# Jeans 2000 Ltd

Plot #67, Sector #07, Export Processing Zone, Chittagong  
(+22.299113N, 91.777006E)

04 November 2013

# Building Observations

**Check column design required**

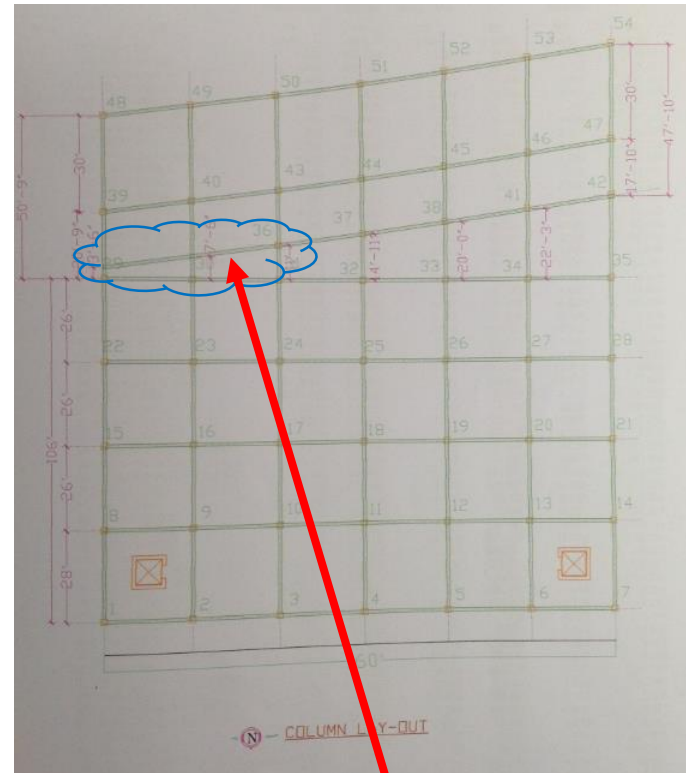
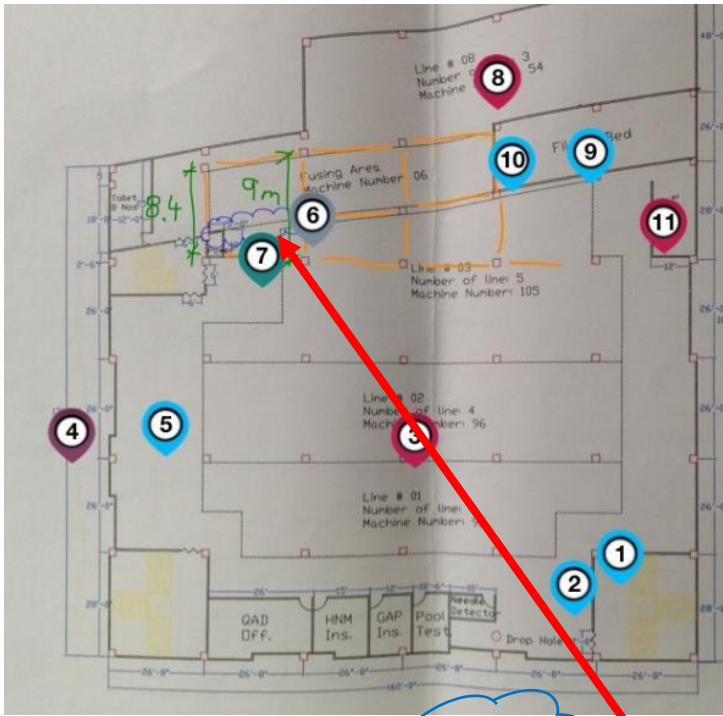
Cursory calculations indicate column working stress is at high level (valid for all columns)

Calculation assume beams at in all column bays.

As built condition shows no beam at this location (all floors)

Engineer is to perform detailed calculations and concrete tests to prove column size and confirm maximum floor loadings. Load management plans to be produced and implemented.

Check on slab design required

## 1<sup>st</sup> Floor

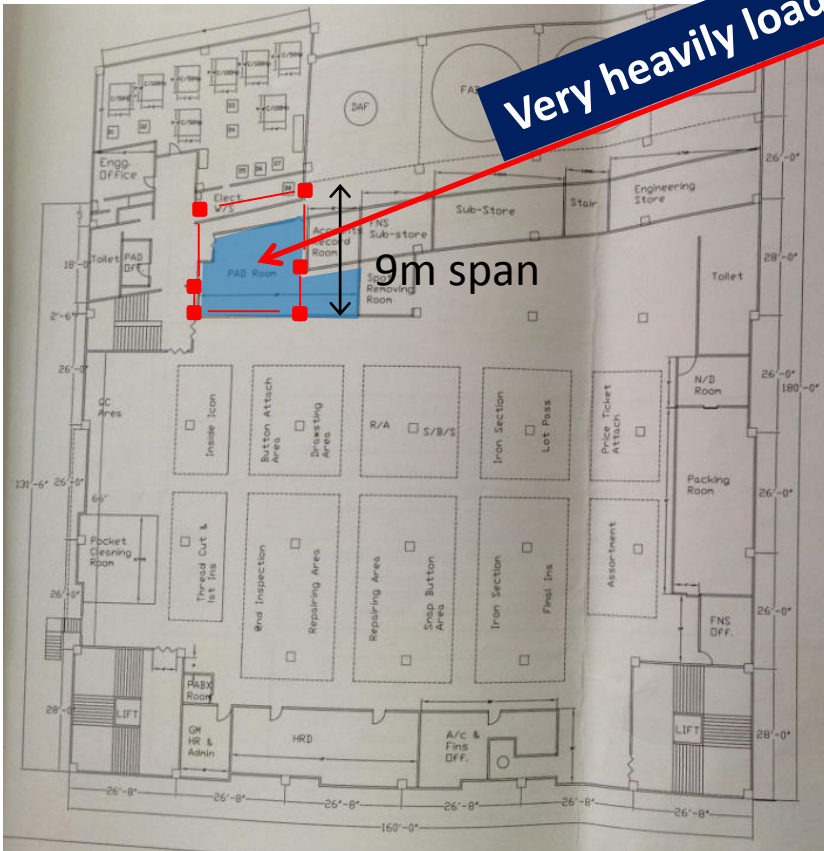
Very heavily loaded area

**Material stacked to ceiling within this room**

**9m span without intermediate beam in this area.**  
**Typical max span is 8.6m everywhere else.**

## Check on slab design required

# **Cracking in column due to corroded reinforcement**

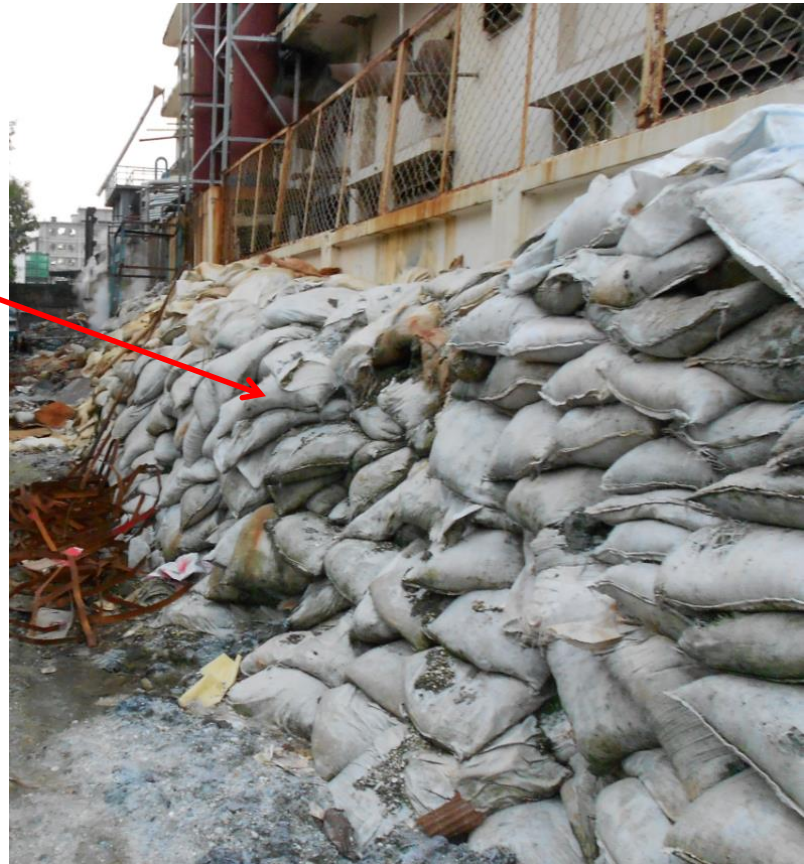
**Water damage in water treatment plant support structure has rusted steel reinforcement, causing spalling of concrete.**

**Cracking in column due to corroded reinforcement**
